World Forum for Harmonization of Vehicle Regulations

Working Party on Passive Safety

Fifty-seventh session
Geneva, 18–22 May 2015

Report of the Working Party on Passive Safety on its fifty-seventh session

Figure 3

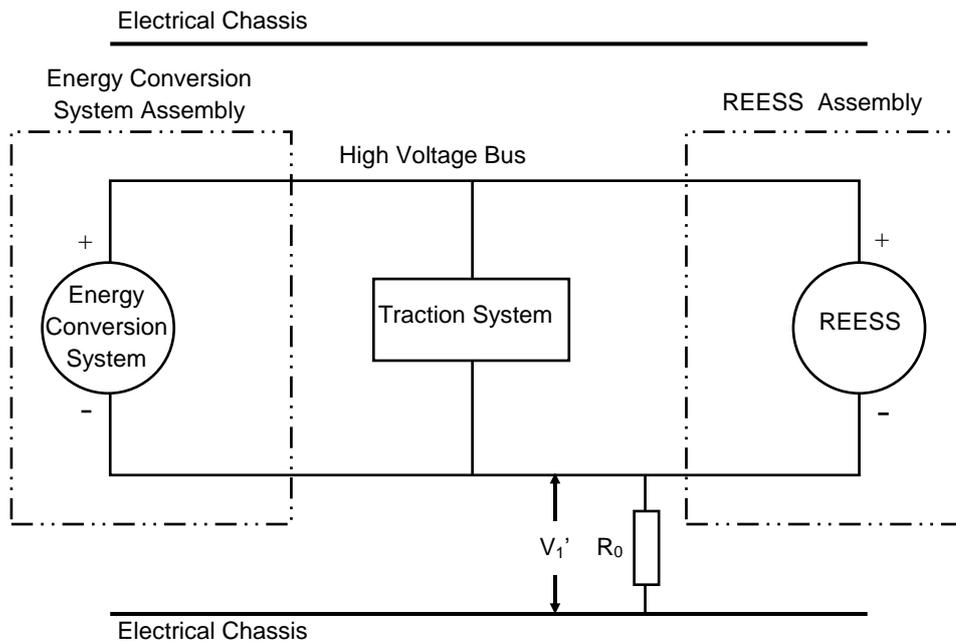
Paragraph 5, amend to read:

"5. Isolation resistance
